Access Audit Site Report

Guadalupe River State Park
3350 Park Rd 31
Spring Branch, TX 78070
Accessibility Evaluation
Inspection Date: 03/21/2022
Inspectors: Tanya Scheibe

Prepared By
WT Group

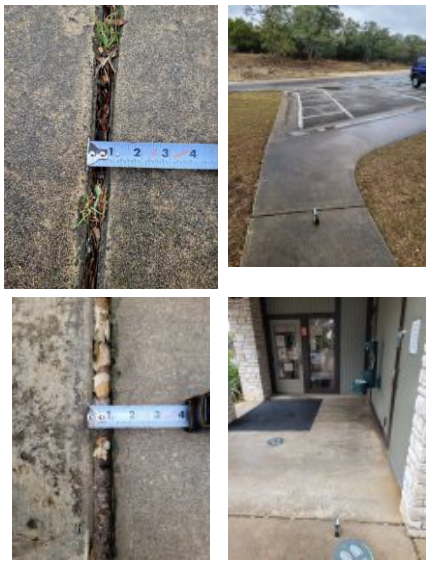
3	Headquarters Area: HQ Parking	[29.8535209, -98.5043987]	The cross slopes (narrow dimension) and/or running slopes (long dimension) of the access aisle exceeds 2%. The running slope and the cross slope in an accessible parking stall and the access aisle must not exceed 2%.	West access aisle, right 3.4%,	Repair or correct slope of parking space and access aisle to max 2.08% in any direction.	2015 ABAAS Section: 502.4 2012 TAS Section: 502.4 2010 ADAS Section: 502.4

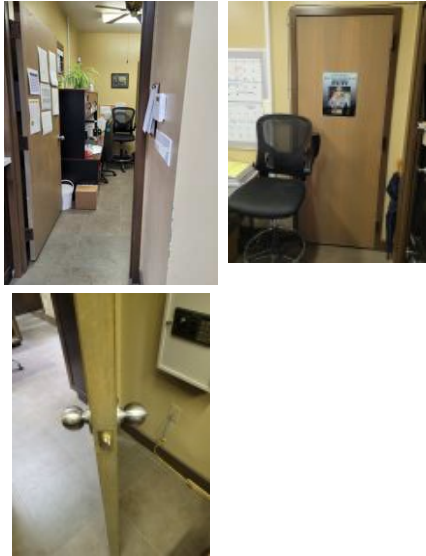
5	Headquarters Area: HQ Exterior Accessible Route	[29.8531786, -98.5043941]	The running slope of walking surfaces shall not be steeper than 1:20.	Route to seating area - 7.4%; entire exterior accessible route exceeds slope limit	Correct running slope along the AR to max 5%.	2015 ABAAS Section: 403.3 2012 TAS Section: 403.3 2010 ADAS Section: 403.3		
6	Headquarters Area: HQ Exterior Accessible Route	[29.85315, -98.50451]	Picnic tables shall provide at least one wheelchair space for each 24 linear feet (7320 mm) of usable table surface perimeter. Wheelchair spaces shall be 30 inches (760 mm) minimum by 48 inches (1220 mm) minimum. Wheelchair spaces shall be positioned for a forward approach to the table and provide knee and toe clearance complying with 306 under the table	Table does not provide wheelchair space or circulation in seating area	Replace table with one with knee and toe clearance, 19" deep at 27" high and 24" deep at 9" high, with a 36" AR around the table at shelter	2015 ABAAS Section: 1011.4.2

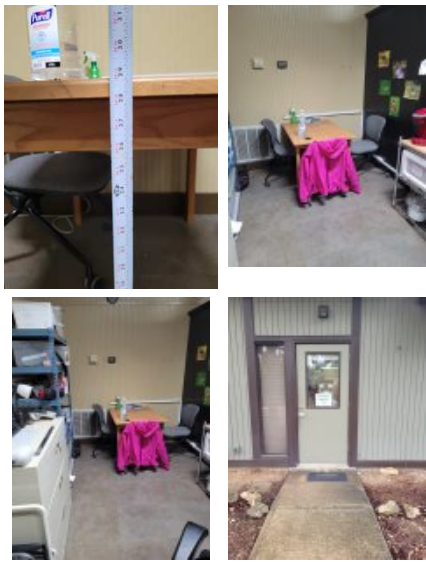
Finding Number	Area Description	Lat/Long	Finding	As Built	Recommendation	Citation	Photos	Figure
7	Headquarters Area: HQ Exterior Accessible Route	[29.8531195, -98.5045636]	There is no accessible route to the seating area and 2 of 2 picnic tables. At least one accessible route shall connect accessible buildings, accessible facilities, accessible elements, and accessible spaces that are on the same site.	Lacks route to seating area and 2 of 2 picnic tables; walkway seen is from employee exit	Create an accessible route with crushed stone or other outdoor material from parking or walkway to eating area and 2 of 2 picnic tables.	2015 ABAAS Section: F206.2.2 2012 TAS Section: 206.2.2 2010 ADAS Section: 206.2.2		
8	Headquarters Area: HQ Exterior Accessible Route	[29.85349, -98.50436]	The curb ramp on the accessible route contains landing slopes greater than 2%. Landing slopes shall not exceed one unit vertical in 48 units horizontal (2-percent slope).	West lot at head quarters - ramp at west accessible stall 17.4%; ramp at east accessible stall at HQ 13%	Correct curb ramp landing slope to max 2.08%	2015 ABAAS Section: 405.3 2012 TAS Section: 405.3 2010 ADAS Section: 405.3

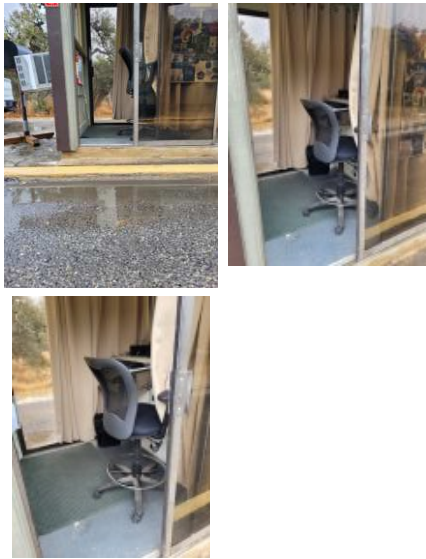
Finding Number	Area Description	Lat/Long	Finding	As Built	Recommendation	Citation	Photos	Figure
11	Headquarters Area: HQ Exterior Accessible Route	[29.8533157, -98.5043479]	There is a gap spaced greater than a 1/2 inch. Openings in floor or ground surfaces shall not allow passage of a sphere more than 1/2 inch diameter. Elongated openings shall be placed so that the long dimension is perpendicular to the dominant direction of travel.	Near west lot - 1", 1" at HQ	Correct or fill gaps to be max .5"	2015 ABAAS Section: 302.3 2012 TAS Section: 302.3 2010 ADAS Section: 302.3		
12	Headquarters Area: HQ Exterior Accessible Route	[29.85327, -98.50443]	Benches shall have a 36" by 48" clear ground space (CGS) positioned near the bench with one side of the space adjoining an outdoor recreation access route (ORAR) or trail, as applicable The CGS shall not overlap with the ORAR or trail or another CGS	bench at HQ lacks CGS	Construct firm, stable, and slip resistant pads at least 36" by 48" adjacent to 20% of benches, and locate along an AR as a smart practice.	2015 ABAAS Section: 1011.2.1

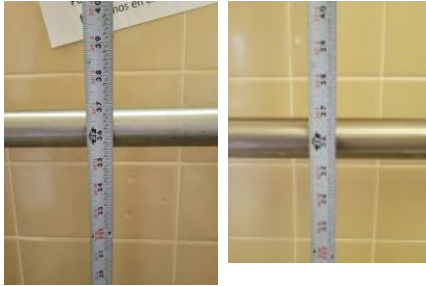
Finding Number	Area Description	Lat/Long	Finding	As Built	Recommendation	Citation	Photos	Figure
23	Headquarters Area: HQ Restrooms	[29.8531673 , -98.504404 1]	An item or items project more than 4 inches into the circulation path. Wall-mounted objects that have leading edges between 27 inches and 80 inches from the floor must not project more than 4 inches into the circulation path. Protruding objects that extend to the floor or within 27 inches of the floor are cane detectable and are therefore not hazardous. Where it is necessary or desirable to have objects protrude from the wall, a manner of cane detection must be provided.	Drinking fountain protrudes 20"	Relocate protruding objects or place cane detectable warning or bollard at foot of item	2015 ABAAS Section: 307.2 2012 TAS Section: 307.2 2010 ADAS Section: 307.2		
24	Headquarters Area: HQ Restrooms	[29.8531452 , -98.504433 6]	The tactile restroom wall sign is missing the International Symbol of Accessibility (ISA). Accessible toilet rooms or bathing rooms shall be identified by the International Symbol of Accessibility (ISA). Wall signs identifying permanent rooms and spaces of a building shall have be horizontal format and the characters raised 1/32 inch minimum and shall be sans serif uppercase characters a minimum of 5/8 inch and a maximum of 2 inches high. Contracted Grade 2 Braille shall be in a horizontal format and shall be placed a minimum of 3/8 inch and a maximum of 1/2 inch directly below the tactile characters; flush left or centered. Signs with raised characters or Braille shall be located 48 inches minimum above the finish floor or ground surface, measured from the baseline of the lowest tactile character and 60 inches maximum above the finish floor or ground surface, measured from the baseline of the highest tactile character.	right- sign lacks symbol of accessibility	Acquire and mount signage, including Braille and access symbol mounted on wall, latch side of door, 48" to baseline of lowest character and 60" to baseline of highest character	2015 ABAAS Section: F216.8 2012 TAS Section: 216.8 2010 ADAS Section: 216.8

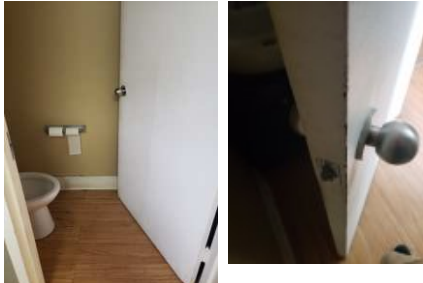
Finding Number	Area Description	Lat/Long	Finding	As Built	Recommendation	Citation	Photos	Figure
27	Headquarters Area: HQ Restrooms	[29.8531418 , -98.504398 7]	The grab bar height and/or spacing fails. Grab bars must be mounted between 33" and 36" to the top of the gripping surface. There must be 1.5" of clearance between the grab bar and the wall. There must be a minimum of 1.5" of clearance below and minimum 12" above the grab bar to any dispenser or other obstruction.	right- side grab bar 36.25", rear grab bar 36.5" above finished floor	Remount grab bars in accessible stall to 33" to 36" above the finished floor (AFF).	2015 ABAAS Section: 609.3, 609.4 2012 TAS Section: 609.4, 609.3 2010 ADAS Section: 609.3, 609.4		
28	Headquarters Area: HQ Restrooms	[29.853165, -98.504425 5]	The toilet paper is not installed within the compliant range in front of the toilet. Toilet paper dispensers shall be 7 inches minimum and 9 inches maximum in front of the water closet measured to the centerline of the dispenser. The outlet of the dispenser shall be 15 inches minimum and 48 inches maximum above the finish floor and shall not be located behind grab bars. Dispensers shall not be of a type that controls delivery or that does not allow continuous paper flow. There shall be a clearance of 1 1/2 inches minimum below the grab bar.	right- multiple TP dispensers, not in compliant range	Remount toilet paper dispenser max 7" to 9" from front of toilet, 15" to 48" aff and min 12" above or 1.5" below grab bar	2015 ABAAS Section: 604.7 2012 TAS Section: 604.7 2010 ADAS Section: 604.7

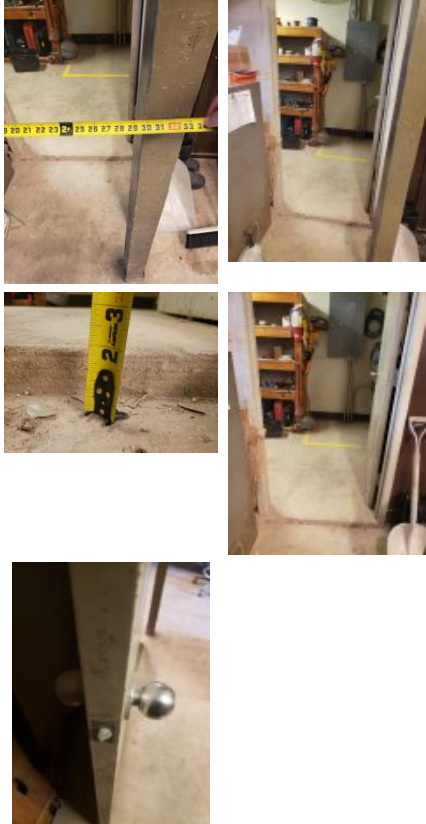
32	Headquarters Area: HQ Restrooms	[29.8531278 , -98.5043853]	The toilet is not located within the range allowed from the side wall or partition. The centerline of the toilet must be 16 to 18 inches from the side wall.	left- centerline 13"	Remount toilets to 16" to 18" from the side wall to centerline	2015 ABAAS Section: 604.2 2012 TAS Section: 604.2 2010 ADAS Section: 604.2

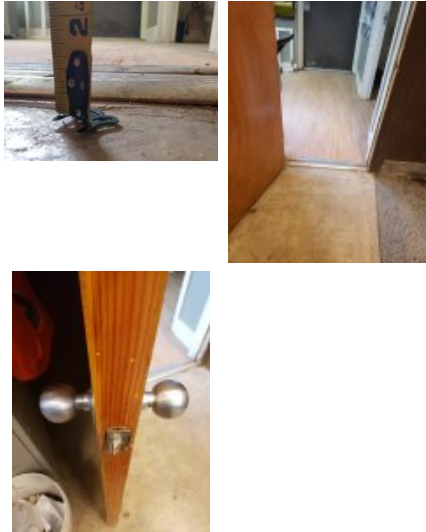
Finding Number	Area Description	Lat/Long	Finding	As Built	Recommendation	Citation	Photos	Figure
33	Headquarters Area: HQ Restrooms	[29.8531511, -98.5043866]	The grab bar height and/or spacing fails. Grab bars must be mounted between 33" and 36" to the top of the gripping surface. There must be 1.5" of clearance between the grab bar and the wall. There must be a minimum of 1.5" of clearance below and minimum 12" above the grab bar to any dispenser or other obstruction.	left- rear grab bar 37" and side grab bar 36.75" above finished floor	Remount grab bars in accessible stall to 33" to 36" above the finished floor (AFF). Remount toilet paper dispenser max 7" to 9" from front of toilet, 15" to 48" above the finished floor (AFF) and min 12" above or 1.5" below grab bar.	2015 ABAAS Section: 609.3, 609.4 2012 TAS Section: 609.4, 609.3 2010 ADAS Section: 609.3, 609.4		
34	Headquarters Area: HQ Restrooms	[29.853129, -98.504388]	The toilet paper is not installed within the compliant range in front of the toilet. Toilet paper dispensers shall be 7 inches minimum and 9 inches maximum in front of the water closet measured to the centerline of the dispenser. The outlet of the dispenser shall be 15 inches minimum and 48 inches maximum above the finish floor and shall not be located behind grab bars. Dispensers shall not be of a type that controls delivery or that does not allow continuous paper flow. There shall be a clearance of 1 1/2 inches minimum below the grab bar.	left- multiple TP dispensers, not within compliant range	Remount toilet paper dispenser max 7" to 9" from front of toilet, 15" to 48" aff and min 12" above or 1.5" below grab bar	2015 ABAAS Section: 604.7 2012 TAS Section: 604.7 2010 ADAS Section: 604.7

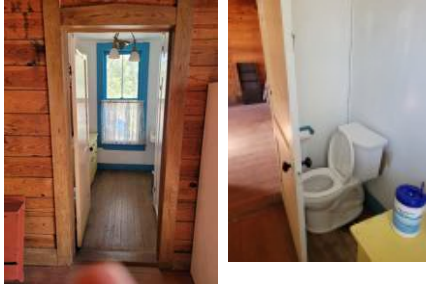
Finding Number	Area Description	Lat/Long	Finding	As Built	Recommendation	Citation	Photos	Figure
43	Employee Areas: Maintenance	[29.8640049 , -98.487876 3]	There is no accessible route to the out buildings. At least one accessible route shall connect accessible buildings, accessible facilities, accessible elements, and accessible spaces that are on the same site.	no accesible route to fuel, carport, and office building	Create an accessible route with crushed stone or other outdoor material from parking or walkway to maintenance facilities	2015 ABAAS Section: F206.2.2 2012 TAS Section: 206.2.2 2010 ADAS Section: 206.2.2

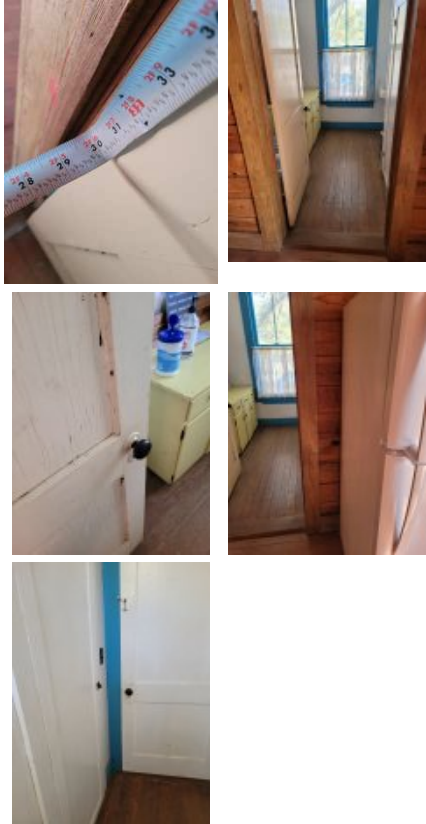
Finding Number	Area Description	Lat/Long	Finding	As Built	Recommendation	Citation	Photos	Figure
44	Employee Areas: Residences	[29.8563659 , -98.505924 9]	The building entrance is not located on an accessible route. When a building, or portion of a building, is required to be accessible, an accessible route of travel shall be provided to all portions of the building, to accessible building entrances and between the building and the public way. All walks, halls, corridors, aisles, skywalks, tunnels, and other spaces that are part of an accessible route must comply. An accessible route of travel must not pass through kitchens, storage rooms, restrooms, closets or other spaces used for similar purposes. At least one accessible route within the boundary of the site must be provided from public transportation stops, accessible parking and accessible passenger loading zones and public streets or sidewalks to the accessible building entrance they serve. The accessible route shall, to the maximum extent feasible, coincide with the route for the general public. At least one accessible route shall connect accessible buildings, facilities, elements and spaces that are on the same site. At least one accessible route shall connect accessible building or facility entrances with all accessible spaces and elements.	residence # 2 - no accessible route to entrance, changes in level; gravel parking	Create accessible parking area that is firm and stable Create AR with crushed and compacted stone or similar outdoor material from parking to residence entrance	2015 ABAAS Section: F206.2.1 2012 TAS Section: 206.2.1 2010 ADAS Section: 206.2.1

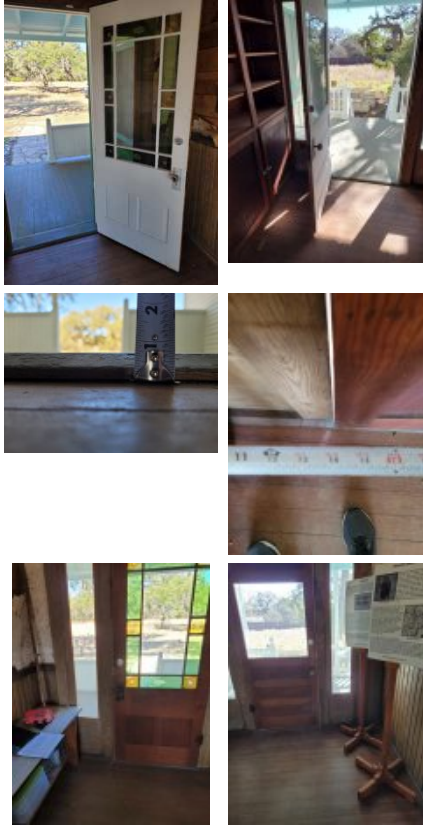
Finding Number	Area Description	Lat/Long	Finding	As Built	Recommendation	Citation	Photos	Figure
45	Employee Areas: Residences	[29.8636328 , -98.4891825]	The building entrance is not located on an accessible route. When a building, or portion of a building, is required to be accessible, an accessible route of travel shall be provided to all portions of the building, to accessible building entrances and between the building and the public way. All walks, halls, corridors, aisles, skywalks, tunnels, and other spaces that are part of an accessible route must comply. An accessible route of travel must not pass through kitchens, storage rooms, restrooms, closets or other spaces used for similar purposes. At least one accessible route within the boundary of the site must be provided from public transportation stops, accessible parking and accessible passenger loading zones and public streets or sidewalks to the accessible building entrance they serve. The accessible route shall, to the maximum extent feasible, coincide with the route for the general public. At least one accessible route shall connect accessible buildings, facilities, elements and spaces that are on the same site. At least one accessible route shall connect accessible building or facility entrances with all accessible spaces and elements.	residence # 1 - no accessible route to building entrance	Create AR with crushed and compacted stone or similar outdoor material from parking or sidewalk to building entrance	2015 ABAAS Section: F206.2.1 2012 TAS Section: 206.2.1 2010 ADAS Section: 206.2.1

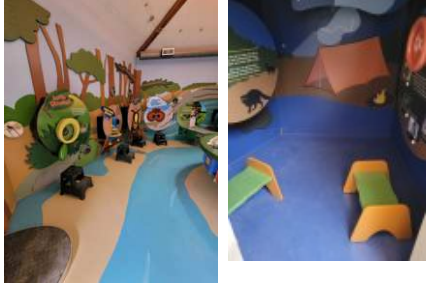
108	Day Use Area: Day Use - Parking	[29.8739064 , -98.484676 4]	There are no van accessible parking stalls. 1 in every 6, minimum of one, required accessible stalls must be a van accessible stall. There are a total of 25 parking stalls in the parking lot that could be reasonably associated with this facility. There should be a minimum of 1 accessible stalls with a minimum of 1 being designed as van accessible.	south of bath house- lacks van space	Add van parking sign to 1 accessible stall and repaint stall and access aisle to 11' and 5' or 8' and 8'.	2015 ABAAS Section: F208.2, F208.2.4 2012 TAS Section: 208.2, 208.2.4 2010 ADAS Section: 208.2, 208.2.4

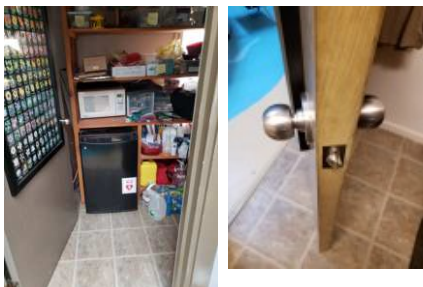
Finding Number	Area Description	Lat/Long	Finding	As Built	Recommendation	Citation	Photos	Figure
113	Day Use Area: Day Use - Parking	[29.8724528 , -98.485271 9]	The parking stall contains abrupt edges and surface irregularities over a 1/4 inch vertical. Parking spaces and access aisles serving them shall be stable, firm, and slip resistant. Access aisles shall be at the same level as the parking spaces they serve. Changes in level are not permitted and shall not be sloped steeper than 2% in any direction.	overflow parking- loose gravel throughout stalls and access aisles	Resurface accessible stalls and access aisles with a firm, stable, and slip resistant material	2015 ABAAS Section: 502.4 2012 TAS Section: 502.4 2010 ADAS Section: 502.4		
114	Day Use Area: Day Use - Parking	[29.8723481 , -98.485137 8]	The accessible route of travel contains cross slopes greater than 2%. Cross slopes shall not exceed one unit vertical in 48 units horizontal (2-percent slope).	overflow parking- exterior accessible route from overflow parking to picnic area - 4% cross slope, 2.9% cross slope	Correct or repair cross slope along AR to max 2.08%.	2015 ABAAS Section: 403.3 2012 TAS Section: 403.3 2010 ADAS Section: 403.3

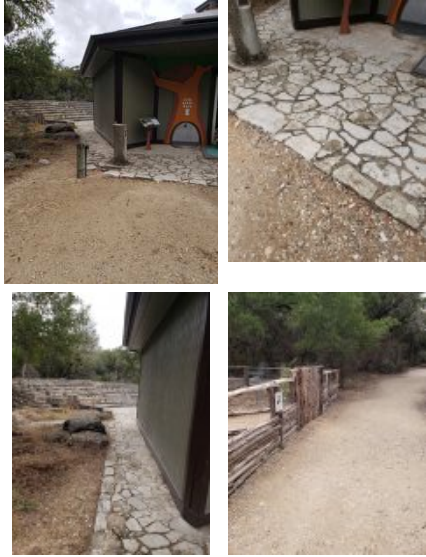
117	Day Use Area: Day Use - Discovery Center	[29.8738575 , -98.486307 2]	The top of the work surface is not within a compliant height range. The tops of tables and counters shall be 28 inches to 34 inches from the floor or ground.	small children's table and another small table	Provide tables and work surfaces at 28" to 34" aff with required knee and toe clearances	2015 ABAAS Section: 902.3 2012 TAS Section: 902.3 2010 ADAS Section: 902.3

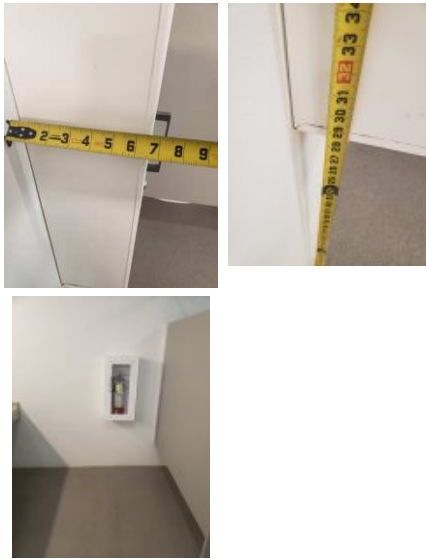
132	Day Use Area: Day Use - Men's Restroom	[29.8743134 , -98.484762 3]	The toilet paper is not installed within the compliant range in front of the toilet. Toilet paper dispensers shall be 7 inches minimum and 9 inches maximum in front of the water closet measured to the centerline of the dispenser. The outlet of the dispenser shall be 15 inches minimum and 48 inches maximum above the finish floor and shall not be located behind grab bars. Dispensers shall not be of a type that controls delivery or that does not allow continuous paper flow. There shall be a clearance of 1 1/2 inches minimum below the grab bar.	Toilet paper dispenser not within compliant range	Remount toilet paper dispenser max 7" to 9" from front of toilet, 15" to 48" aff and min 12" above or 1.5" below grab bar	2015 ABAAS Section: 604.7 2012 TAS Section: 604.7 2010 ADAS Section: 604.7

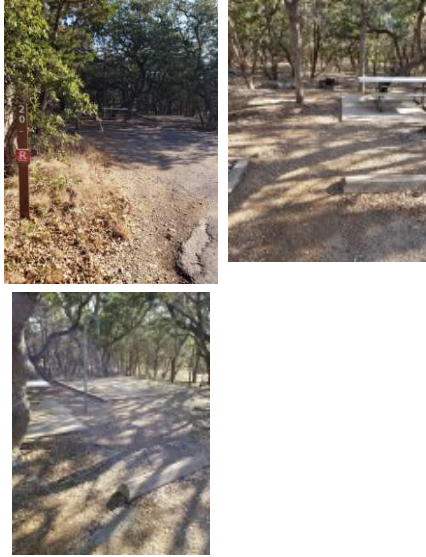
160	Day Use Area: Day Use - Picnic Area	[29.8750367 , -98.4850707]	The ramp run has not been provided with edge protection. The floor or ground surface of the ramp run or landing shall extend 12 inches minimum beyond the inside face of a handrail or a curb or barrier shall be provided that prevents the passage of a 4 inch diameter sphere, where any portion of the sphere is within 4 inches of the finish floor or ground surface.	ramp lacks edge protection	Extend ramp ground surface to 12" min from inside of handrail to edge of ramp or install rail along bottom edge of ramp that prevents a 4" sphere from passing through	2015 ABAAS Section: 405.9, 405.9.1, 405.9.2 2012 TAS Section: 405.9.1, 405.9.2, 405.9 2010 ADAS Section: 405.9.2, 405.9.1, 405.9		
161	Day Use Area: Day Use - Bird Blind	[29.85591, -98.50416]	Element meets all standards and requirements	parking scoping complies- 1 accessible, 5 standard	None	2010 ADAS Section: N/A

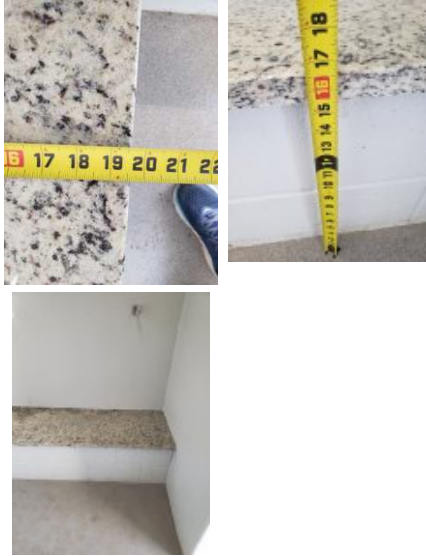
171	Day Use Area: Day Use - Changing Room	[29.874239, -98.484762 3]	Exterior doors exceed 8.5 lbs of force to open; fire doors shall have a minimum opening force allowable by the appropriate administrative authority	Accessible changing room door - 15# push	Inspect, adjust, and maintain 8.5 lbf to open exterior doors as a smart practice.	2010 ADAS Section: 404.2.9
